AMERICA'S CUP 36

Interpretation 068

AC75 Class Rule Version 1.23 issued 29th December 2020

Figure 1: System A: Loaded sheet in red, unloaded sheet in green. The tracks to adjust the jib sheeting positions are shown in black. The thin black line indicates LCP.

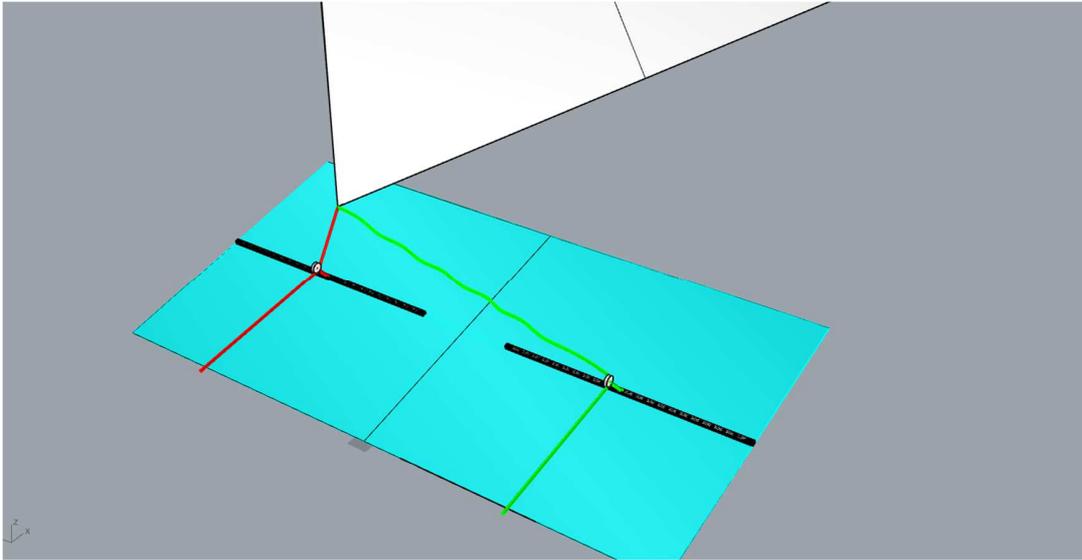
A **headsail** sheet system is mounted on the **deck**. The system consists of two sheets (one port and one starboard), two winches (one port and one starboard) and two deflectors (one port and one starboard), as permitted by rule 19.13. No system is installed that guides or could guide the sheet between the port and starboard sheeting position and the headsail sheets are not guided by other means. It is assumed for the purpose of this RFI that the system and its usage otherwise comply with rule 19.13 and the **RC's** related interpretations.

Figure 2: System B: As System A, fairing added with slot for jib sheets (grey).

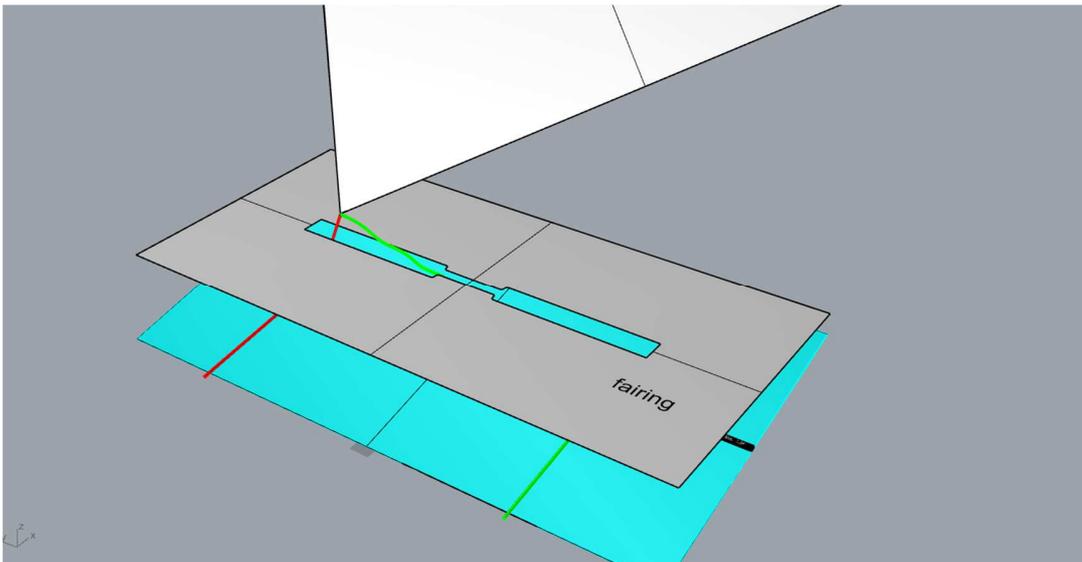
A system, identical to System A is now installed underneath an aerodynamic fairing. The fairing does not move, has no moving parts, and has no moving parts attached to it. The top side of the aerodynamic fairing is approximately flush with the surrounding **deck**. The fairing has a slot to provide a passage for the **headsail** sheets from the deflectors underneath the fairing to the clew of the **headsail**. The slot is entirely forward of **MRP** and not further forward than 10.150 in front of **TRP**. It is approximately perpendicular to **LCP**. The slot creates a sufficient aperture for the full range of sheeting positions (see figure below).

1. Is System B, described above, compliant with rule 19.11. If not, please advise for what reason.
2. Is System B, described above, compliant with rule 19.12. If not, please advise for what reason.

Rule 19.13 defines the only ways to control a **headsail** sheet. Thus, if a taut jib sheet is in contact with any part of the yacht between the deflector and the clew, the **Rules Committee** deems this to be a further means of control, prohibited by Rule 19.13(b). That applies for all trim and sail settings.

1. Yes, If the starboard sheet never contacts the slot on the port side, and if the port sheet never contacts the slot on the starboard side.
2. Yes, If the starboard sheet never contacts the slot on the port side, and if the port sheet never contacts the slot on the starboard side.
